Work Order ID 97921

Item Name: Bracket Assembly

D3303-041 HEAD REST

DRAWING NO D3303	TITLE HEAD REST	REV. B	DART AEROSPACE LTD ENGINEERING ORDER		D.E.O. NO D3303-B-1	SHEET NO. SHEET 1 OF 1	SCALE NTS
DRAWN AJS	CHECKED b	MFG. APPR. M	APPROVED MJD		DE APPR. H		
DATE 08.10.15	DATE 08.10.15	DATE 08/10/16	DATE 08/10/16		DATE 08/10/16	DATE 08/10/16

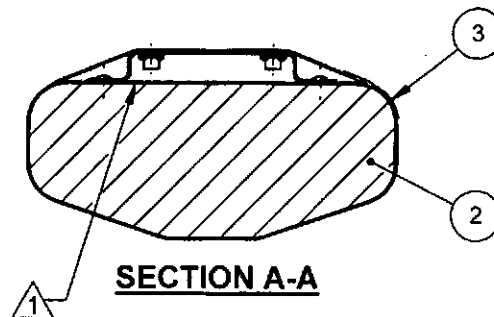
SHEET 1 ADD 1300L ADHESIVE BY 3M TO NOTE 1 AS FOLLOWS:

WAS:

- 1) BOND D3305-1 FOAM TO D3303-043 BRACKET ASSEMBLY USING 3M 1300 ADHESIVE (0.002" TO 0.010" THICK) IN ACCORDANCE WITH MANUFACTURER'S INSTRUCTIONS

IS:

- 1) BOND D3305-1 FOAM TO D3303-043 BRACKET ASSEMBLY USING 3M 1300 OR 1300L ADHESIVE (0.002" TO 0.010" THICK) IN ACCORDANCE WITH MANUFACTURER'S INSTRUCTIONS
